# APPLICATION NOTE

**Product Family: Productivity 3000**

**Number: AN-P3-001**

**Subject: ASCII communication differences  
before and after V1.0.9.23**

This example logic will work with firmware 1.0.9.23, but not firmware starting with 1.0.10.20:

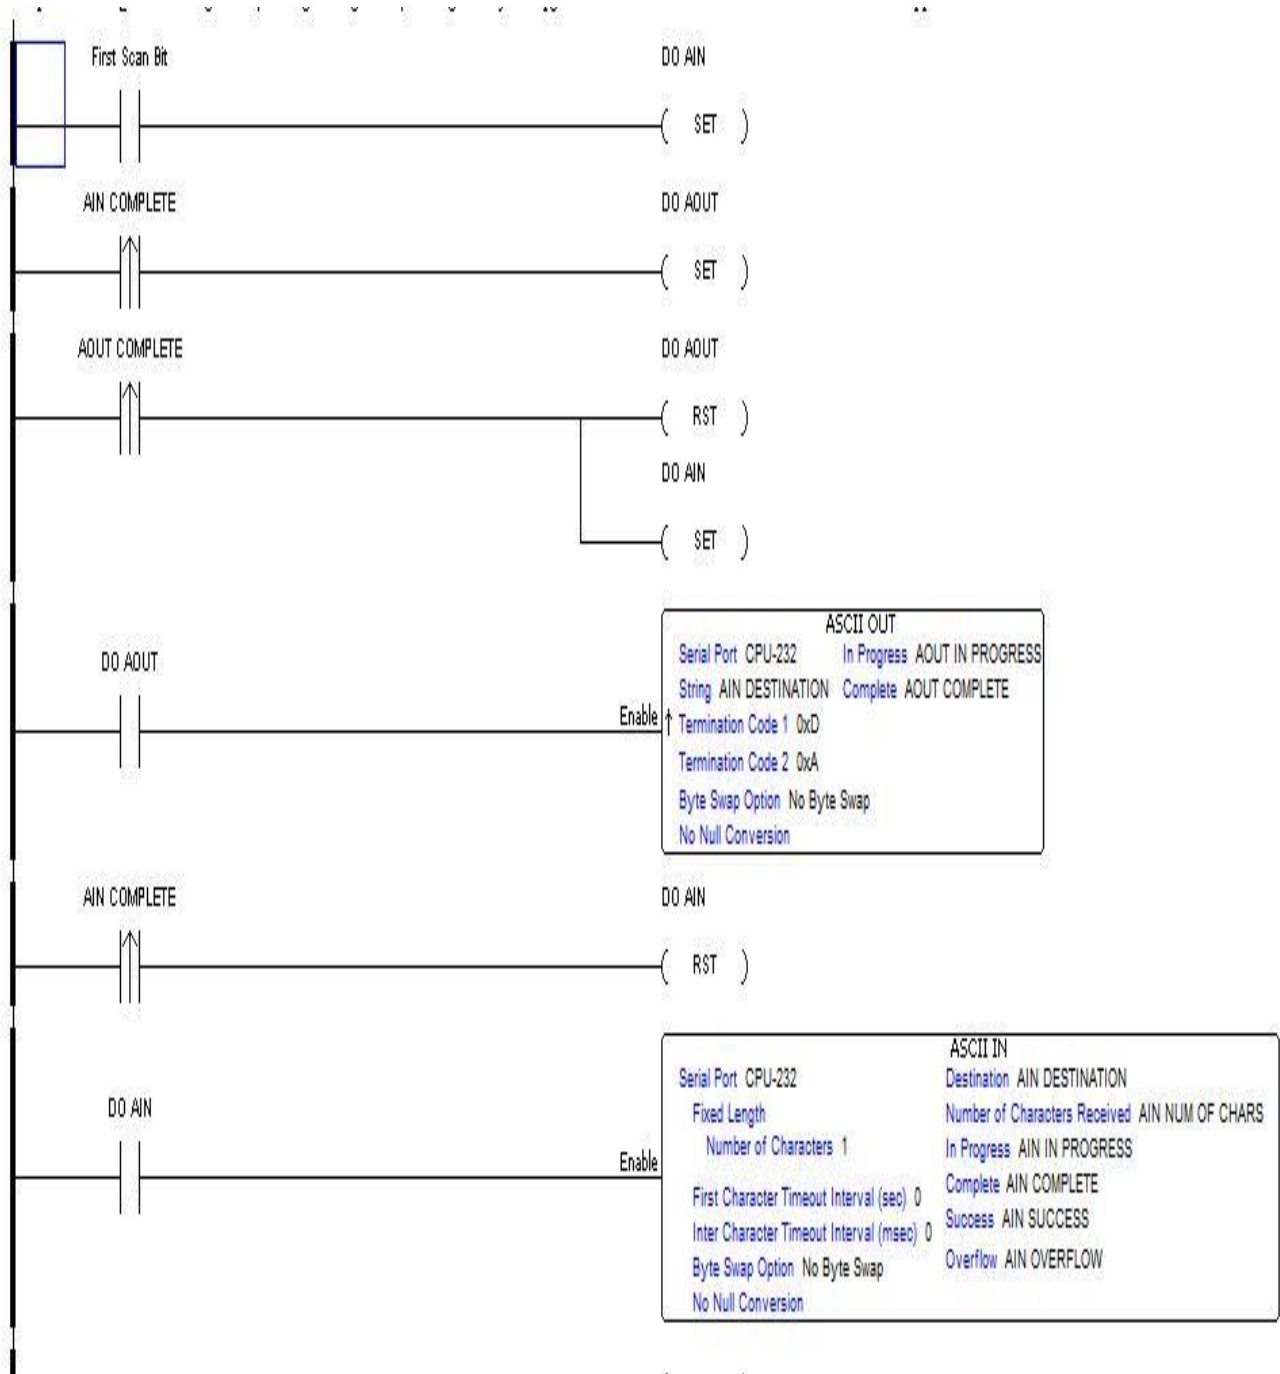
There was a change made to the way the ASCII Out instruction in the P3000 handles data between firmware 1.0.9.23 to 1.0.10.20.

In 1.0.9.23 the ASCII Out instruction could buffer data.

In 1.0.10.20 this was changed so the ASCII Out cannot buffer data to avoid buffer overflow issues and unexpected data being sent.

Because of this behavior the ASCII In and ASCII Out could both be enabled in the same program scan and the ASCII Out would buffer the data until a scan was made and the ASCII In was not enabled and data would be sent. Therefore it was not required to interlock the ASCII In and ASCII Out instructions. This was ok unless it was several scans until the ASCII In was not enabled and then it would result in buffer or data issues. In the new firmware the ASCII In and ASCII Out instruction must be interlocked to avoid them being enabled on the same program scan since the ASCII Out can no longer buffer data. If they are not interlocked and the ASCII In is always active the ASCII Out will never send data.
